A19 NORTH ROAD, BROOKE'S GARAGE

Road Safety Review
Client: Mr Robin Wilson

ISSUE	REVISION	DESCRIPTION	DATE	PREPARED BY	CHECKED
1	-	Draft	03 March 2022	<i>M Hedley</i>	<i>M Morley</i>
2	A	Final	08 March 2022	<i>M Hedley</i>	<i>M Morley</i>
3	B	Final	17 March 2022	<i>M Hedley</i>	<i>M Morley</i>
Document number - RSI-MH-0222-002 Issue 3.0

Figure 1.2 – Planning Application (2022) Plan

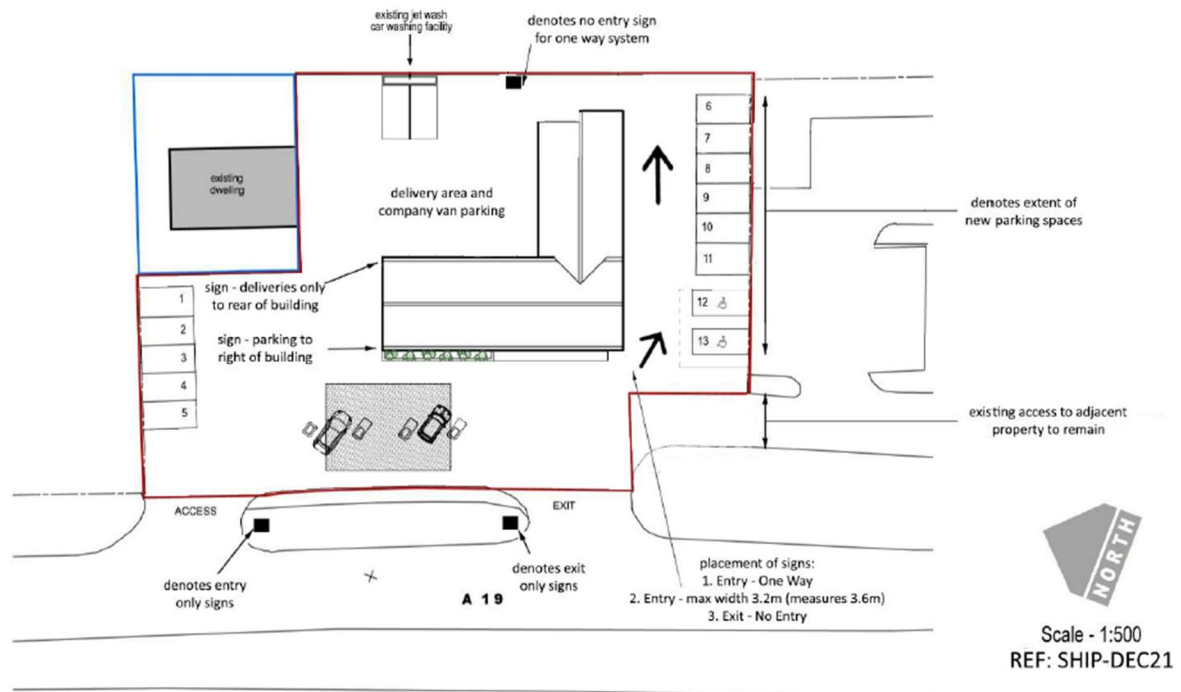
- 1.3.4 There is currently a planning application which has been submitted to Hambleton District Council, the local planning authority. The application description is shown in the extract below, along with the application layout plan in **Figure 1.2**.

Appendix A: Location Plan

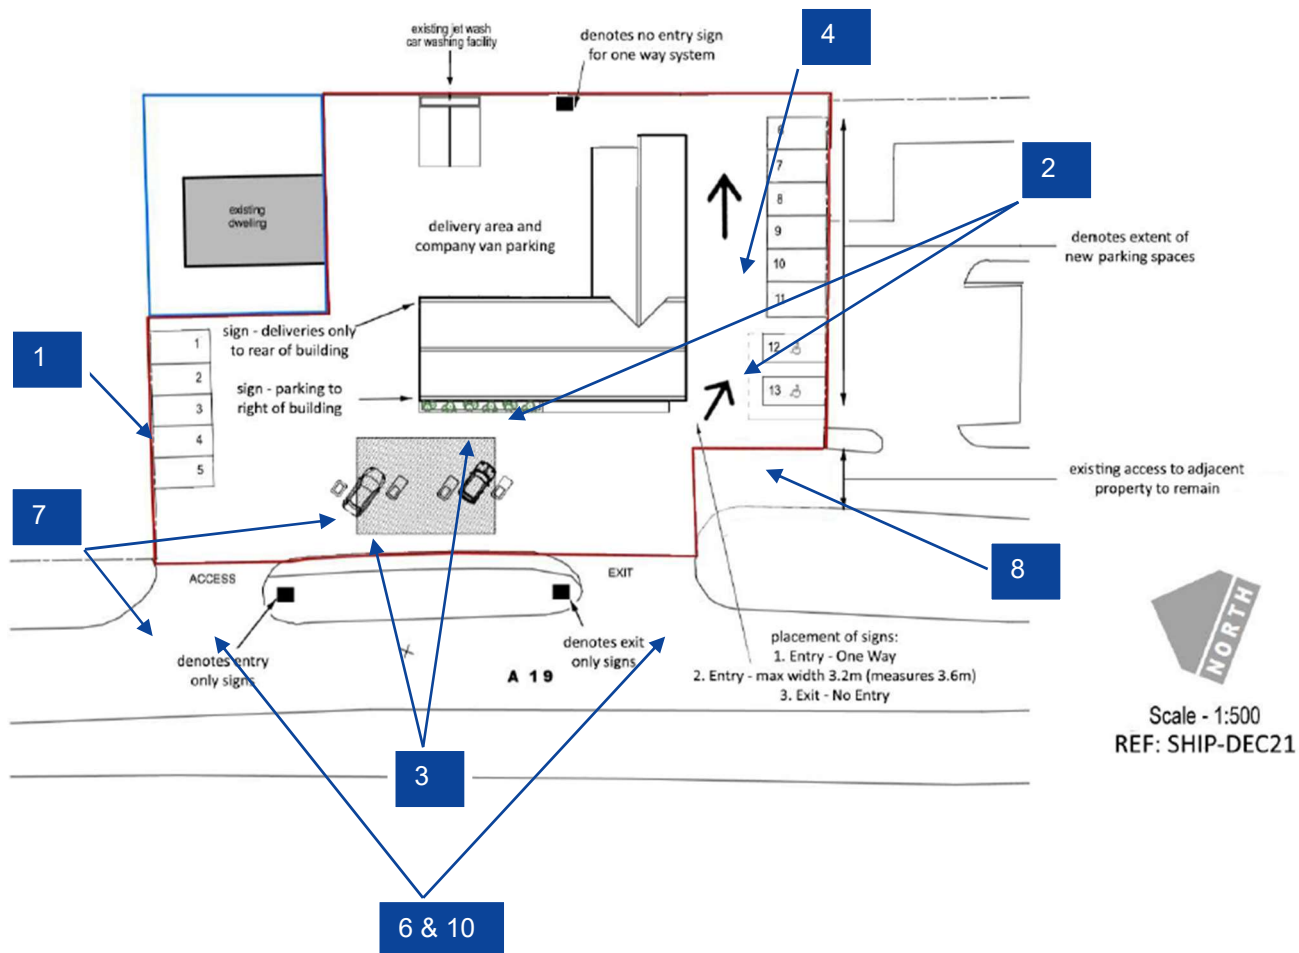
- 3.2.1 The potential hazards identified from the site visit and desktop review of the information supplied are recorded in **Table 3.1** below. These hazards will be taken forward to Section 4 to be 'risk assessed'.
- 3.2.2 All hazards identified are referenced to the planning drawing in **Appendix A**.

Ref	Potential Hazard	Additional commentary
1	Conflicts resulting from vehicles entering/egressing parking bays 1 – 5 at the northern end of the site	It may be a challenge for drivers to enter/egress the parking bays. The orientation, closeness to northern access (inter-visibility between turning traffic and parking bays), reversing movements may individually or collectively lead to conflicts.
2	Conflict between vehicles entering parking bays 6 – 13 (south side of the shop) and vehicles egressing the fuel pumps.	Vehicles have to travel through the forecourt to access parking bays 6 – 13.
3	Pedestrians at risk of being struck.	The overall access/egress arrangements throughout Brooke's Garage may increase conflict likelihood. In addition, vehicle occupants in the queuing traffic or those on A19 verge walking through the forecourt to access the shop or refreshment facilities. Inappropriate driver behaviour, and vehicle manoeuvres including reversing due to other hazards identified.

Ref	Potential Hazard	Additional commentary
4	Conflicts between drivers entering/egressing Brooke's Garage from parking bays 6 – 13 and other vehicle movements.	There is a strategy to access parking bays 6 – 13 (through the forecourt) however, there is ambiguity regarding the direction by which drivers egress Brooke's Garage from these bays. (For example, do drivers exit using the same route by which entered, or do they travel around the rear of the building, in a 'one-way' arrangement?). In addition, it would appear that a vehicle may be a conflict with an opposing traffic flow and / or may even use the northern access to re-join the A19.
5	Fuel deliveries/servicing – Vehicles may cause disruption to the operation of the site and increase conflict risks.	There is an apparent lack of clarity of where and how deliveries/servicing is achieved. This confusion can additionally lead to a blocked point of access.

6	Drivers entering/egressing Brooke's Garage accesses from/to the A19 (present layout /future layout).	Currently there is no clear instruction to drivers to inform them of the correct use of the northern and southern accesses. This results in conflicts between opposing traffic, as well as conflicts between vehicles within the internal layout.
7	Forecourt arrangement results in vehicles backing onto or close to the A19 carriageway.	The layout of the forecourt and fuel pumps, the lack of 'stacking capacity' (and likely increased waiting times for those making use of the on-site facilities) currently results in vehicles queuing back onto the A19 carriageway. In addition, this results in the blocking of the through route to the Wilson Building and associated car parking.
8	Vehicles unable to manoeuvre through the proposed route due to barriers/bollards (particularly delivery vehicles).	If the barriers/bollards remain insitu it will impact on the movement around the site and access/egress may not be achievable. This could result in vehicles needing to reverse, increased queues and/or block through routes. Vehicles may even use the northern access to re-join the A19.

9	Tracking of large vehicles through the site may not be achievable. (Particularly delivery vehicles).	It is unclear whether large vehicles are able to manoeuvre through the site in forward gear only. If several movements are required in forward and reverse gear it may lead to conflicts.
10	Additional facilities may increase visitors – This may result in hazards on the A19. Frustrated drivers may reverse onto the A19 carriageway leading to conflicts.	Additional turning movements to/from the A19 and stationary/slow moving vehicles entering the site may increase the potential for conflicts. Drivers may reverse onto the A19 carriageway if they struggle to gain access or are frustrated by perceived or actual delays.
11	Inadequate parking may lead to inappropriate parking behaviour.	Parking spaces may be occupied by the residential property owner/visitors and/or staff. Brooke's Garage appears a popular site and the designated parking bays may not be adequate in any case.

Ref	Potential Hazard	Additional commentary
12	Buildings may impede inter-visibility between driver/driver and/or pedestrian/driver.	Sight lines may be impeded by the building and could exacerbate potential hazards identified in Ref 4, 5, 8 & 9. The restricted sight lines are a hazard to pedestrians walking around the site.
13	Deliveries taking place from the A19 carriageway leading to conflict.	Deliveries may take place from the A19 due to issues identified in this section.

- 5. Fuel deliveries/servicing
- 9. Tracking of large vehicles
- 11. Parking throughout
- 12. Buildings impeding visibility
- 13. Deliveries from A19

Hazard Ref	Risk	Severity	Likelihood	Risk Value	Mitigation to address risk
1	Potential for vehicle-to-vehicle conflicts between those entering/egressing parking bays and those entering the garage.	2	3	6	<ul style="list-style-type: none"> • Relocate/re-orientate parking bay layouts. • Ensure inter-visibility is provided.
2	Potential for vehicle-to-vehicle conflict (side impact). Drivers surprised and ‘fail to look properly’ by vehicles travelling through forecourt (possibly at inappropriate speeds), when egressing fuel pumps.	2	3	6	<ul style="list-style-type: none"> • Provide measures to improve driver awareness of traffic movement. For example, road markings, surface colouring etc. • Mark out fuel pump areas and ensure inter-visibility between drivers and adequate route widths. • Review and change fuel pump layout. • Re-route vehicles. • Reduce vehicle speeds, i.e. speed limit signs, speed bumps.

6	Potential for head-on type collisions with opposing traffic. There is also the potential for side impact and rear end shunts on the A19 if resulting conflicts effect the A19.	3	4	12	<ul style="list-style-type: none"> Provide clear and unambiguous signing strategy. Provide a right-turning bay for stationary/right turning vehicles.
7	Potential for rear shunts if vehicles queue back onto/towards the A19.	3	4	12	<ul style="list-style-type: none"> Review and change fuel pump layout and vehicle routeing.
8	Potential for vehicle-to-vehicle conflicts if access is blocked leading to injudicious driver behaviour.	3	5	15	<ul style="list-style-type: none"> Discuss and agree movement of barriers/bollards. If the above is not achievable, layout and routeing strategy will need to be reviewed and amended.
9	If large vehicles can't manoeuvre through the site in forward gear and require several movements, it could	2	3	6	<ul style="list-style-type: none"> Carryout a swept path analysis of the garage layout. If necessary, layout and routeing

13	Collisions may occur if deliveries take place from A19. Incidents may include head-on and rear end collisions on the A19, and pedestrian collisions with garage layout.	3	4	12	<ul style="list-style-type: none"> Provide a delivery protocol which ensures no deliveries from the A19. Internal layout and queuing will also need to be addressed.
